**EXHIBIT LIST FOR SUB 2025-001/EA 2025-007
Preliminary Plat of Cottonwood Run**

STAFF REPORT TO THE BENTON COUNTY PLANNING COMMISSION

FILE NO: SUB 2025-001 – Preliminary Plat of Cottonwood Run

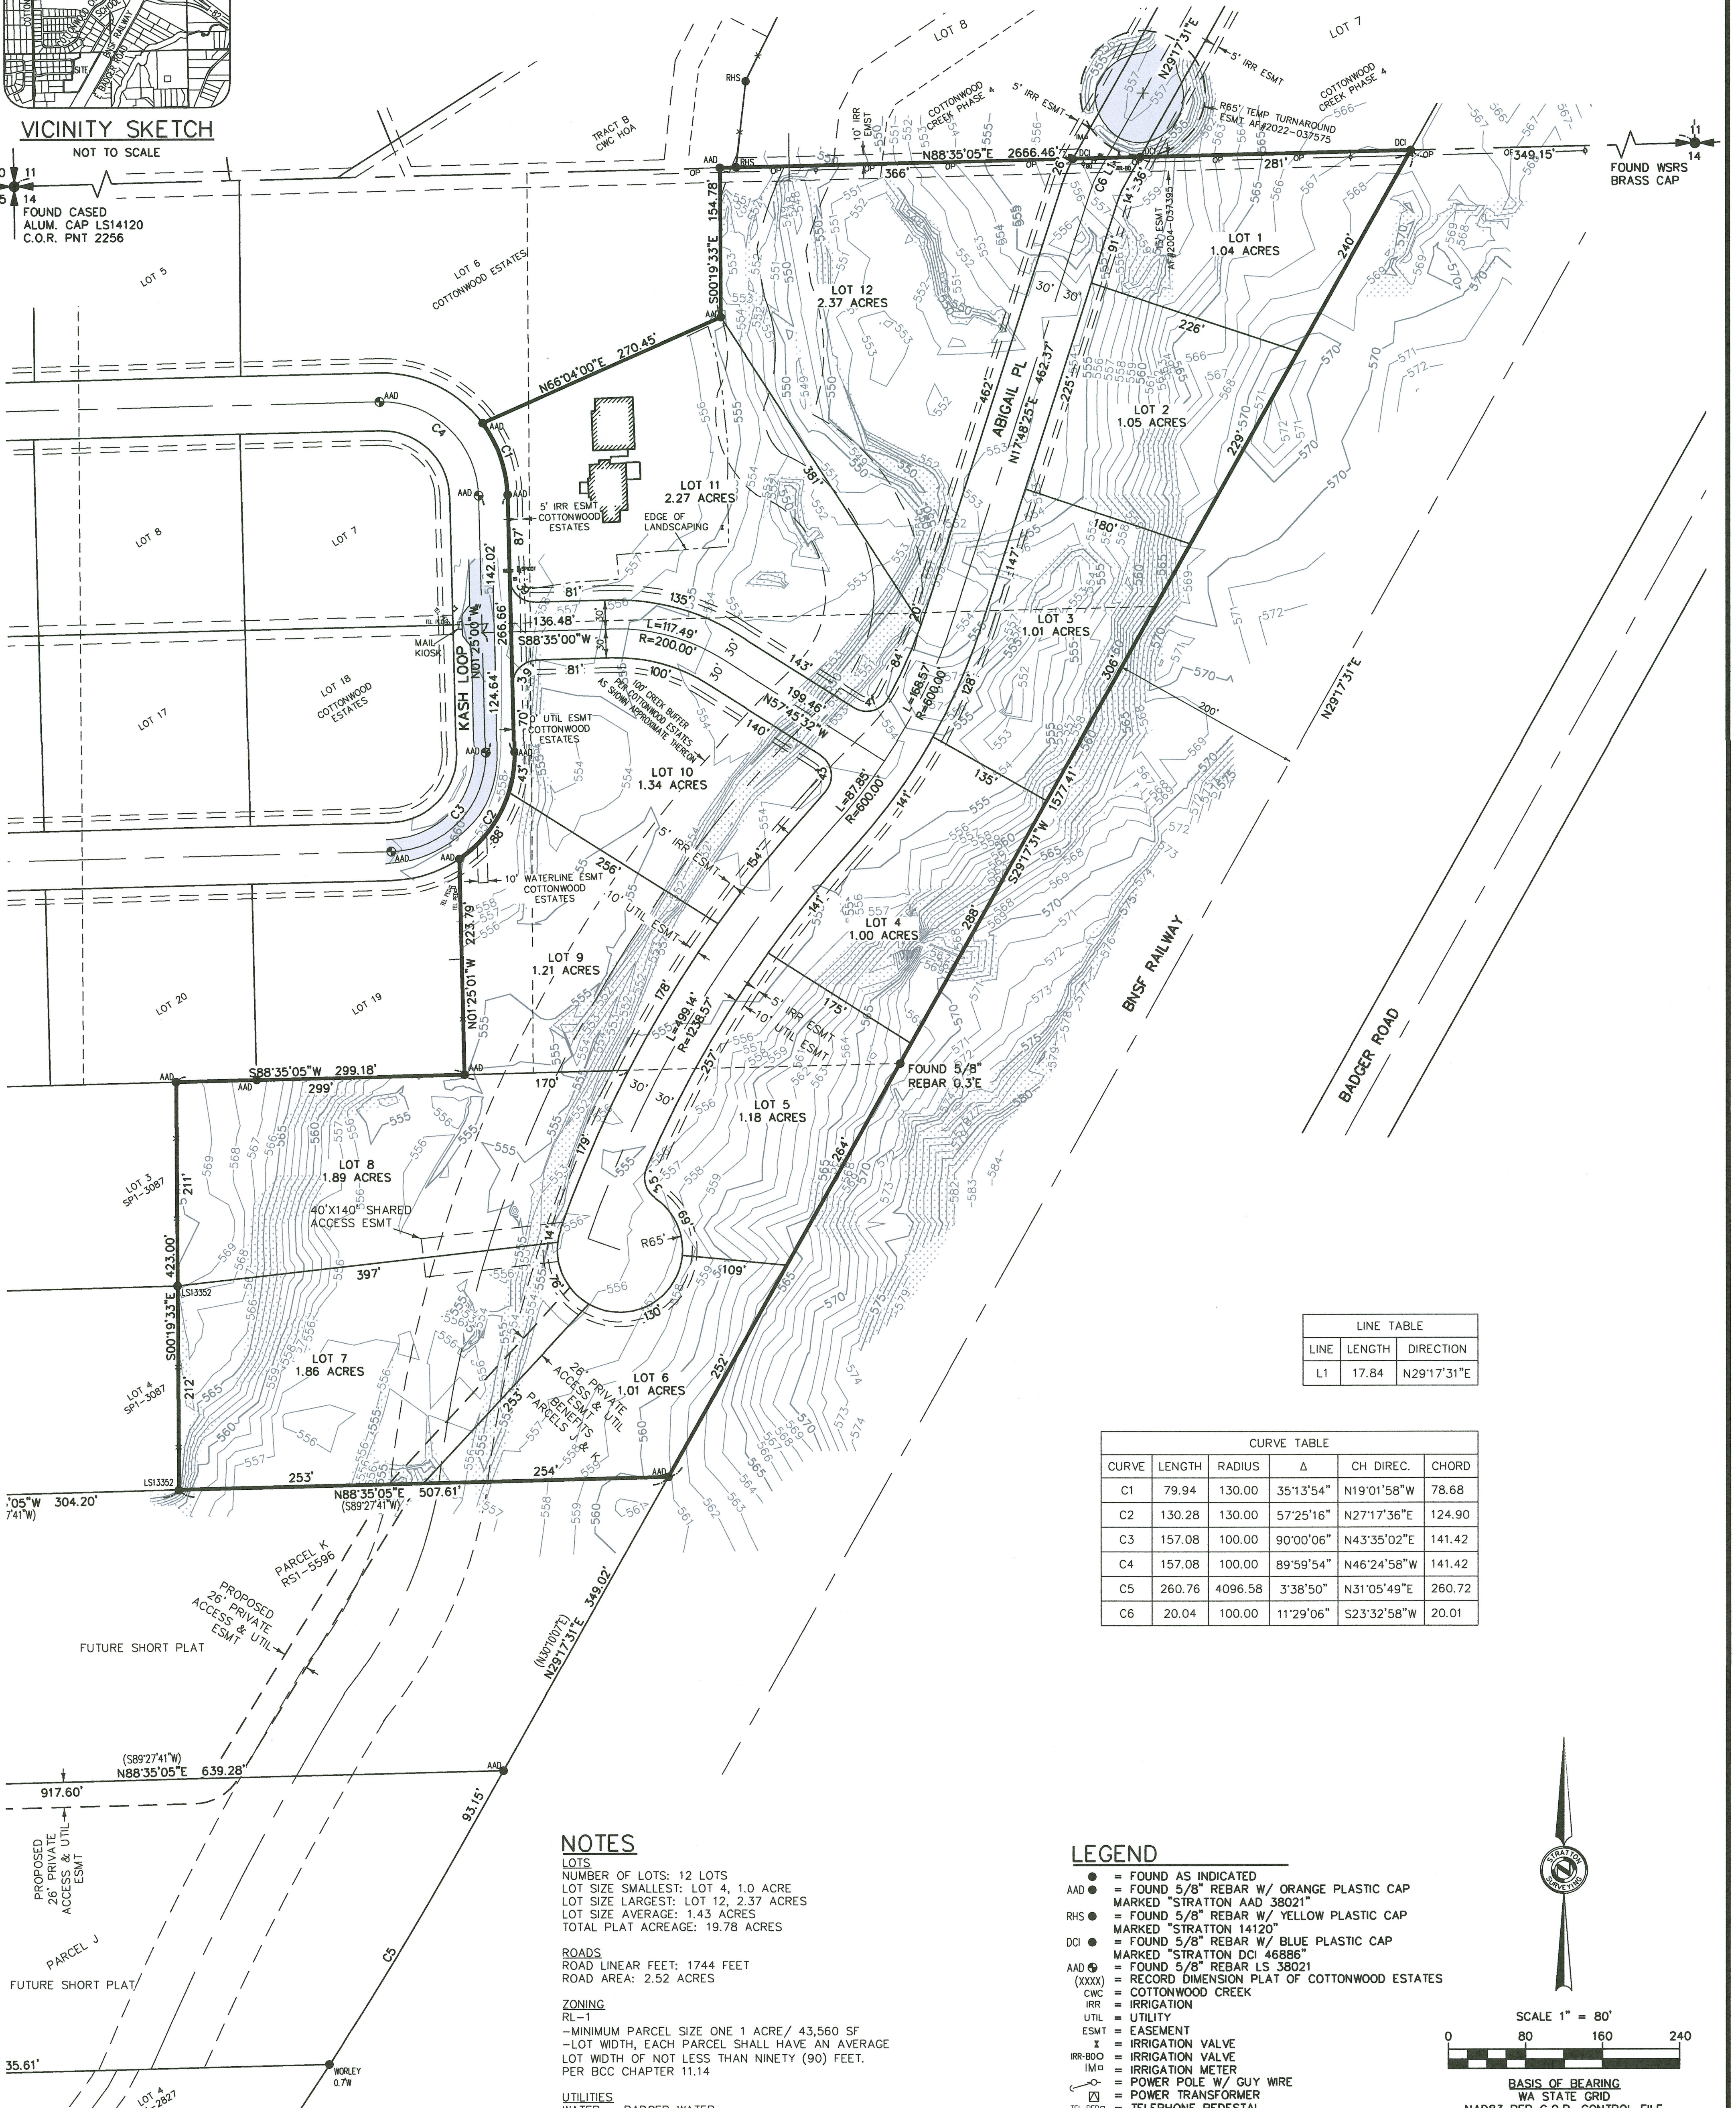
- i. Access on lot 7 and 8 is restricted to the shared 40-foot easement, show driveway on plat using Benton County Standard R-4 using the urban local access cross section.

- j. Provide crossing over drainage easement on lot 7 and 8 to include required culverts.
 - k. Show driveways for lot 11 on face of plat and show additional dwelling on lot 11.

- l. Provide paved driveway following Benton County standard plan R-3, for additional dwelling on lot 11 off of new road connecting to Kash Loop.
 - m. Label new road connecting to Kash Loop.

- o. Remove temporary turnaround in easement AF# 2022-037575 in lot 7 and 8 of Cottonwood Creek Phase 4. Restore ditches and shoulder to county standards.

- p. If present restore landscaping and approaches on lot 7 and 8 of Cottonwood Creek Phase 4.
 - q. Dedicate 60' of right of way to Benton County for road purposes. (The plan shows 30 feet each side of centerline with no description of what the 30 feet is for).

- c. Please show and label any areas within the plat with slopes over 15%.
- d. Add building setback envelopes to Lots 3, 4, 6, and 9.
- e. Per Benton County Code 9.09.010(d)(2) new private road easements are not permissible within new a subdivision. Please remove the 26' private access easement to benefit parcels J and K.

- h. Remove the label reference to "future short plat" on the parcels south of the subject property.

- i. Add the developer/owners address and phone number to the plat map.
7. Please include the following notes on the final plat:
 - a. During construction on each property, all construction debris shall be maintained on-site and properly disposed of. Dust control measures including an adequate water supply shall be provided.
